GENERAL MOTORS
DCS7578
URGENT - DISTRIBUTE IMMEDIATELY

Subject: N262570770 - Service Update
Radiator Thermal Break Tabs

Models: 2023 – 2025 Cadillac XT5
2023 – 2025 Cadillac XT6
2024 – 2025 Chevrolet Blazer

N262570770 Radiator Thermal Break Tabs

7213566

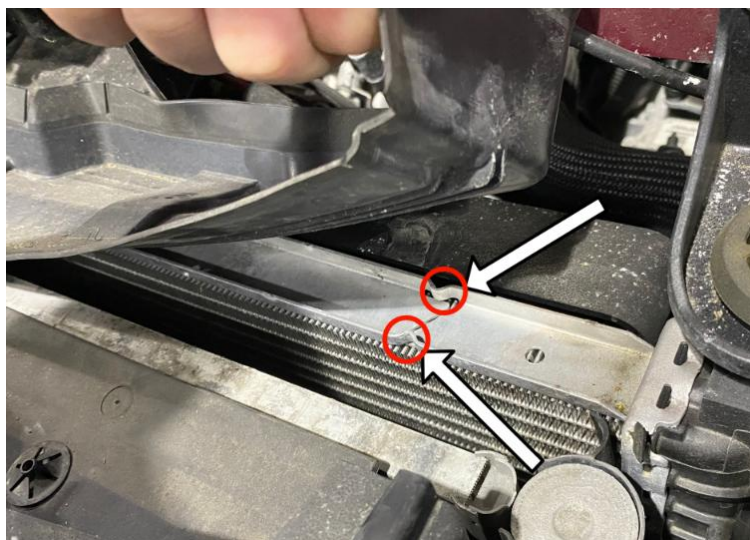
Condition	Certain vehicles listed above may have a condition in which the thermal break tabs induce stress into the radiator causing a coolant leak.
Correction	Dealers are to cut the thermal break tabs on the radiator.

2. Carefully pull back the sides of the Radiator Air Upper Baffle and cut the thermal break tabs (4 in total) on both the left and right hand sides of the radiator with side cutters.
3. Reinstall the Intake Air Splash Shield. Refer to *Intake Air Splash Shield Replacement* in SI.
